AMENDMENT NO. 1 MARCH 1981
TO
IS : 1362 - 1975 SPECIFICATION FOR STUDS
(Second Revision)

Alterations

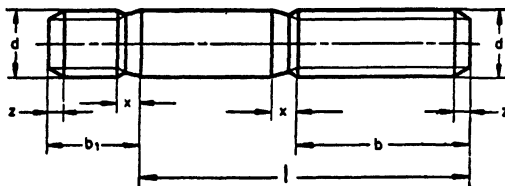
(Page 1, clause 3) — Substitute the following for the existing clause:

'3. Types — Three types as follows:

Type A — $b_1 \approx 1 d$, suitable for use in steel.

Type B — $b_1 \approx 1.5 d$, suitable for use in cast iron.

Type C — $b_1 \approx 2 d$, suitable for use in aluminium alloys.

Note — For values of b_1 , see Tables 1 and 2.

(Page 2, Table 1):

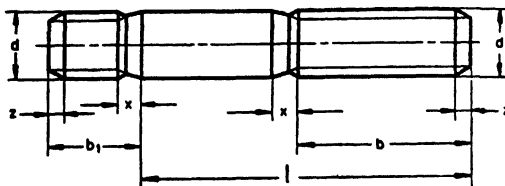
a) *Figure* — Substitute the following for the existing figure:

z according to IS : 1368-1967 ' Dimensions of ends of bolts and screws (first revision) '.

x according to IS : 1369-1975 ' Dimensions of screw thread runouts and undercuts (first revision) '.

Note — Machined threads and rounded end at nut end also permitted.

b) *Tenth Column, last three entries* — Substitute the following for the existing entries:

20

20.65

19.35
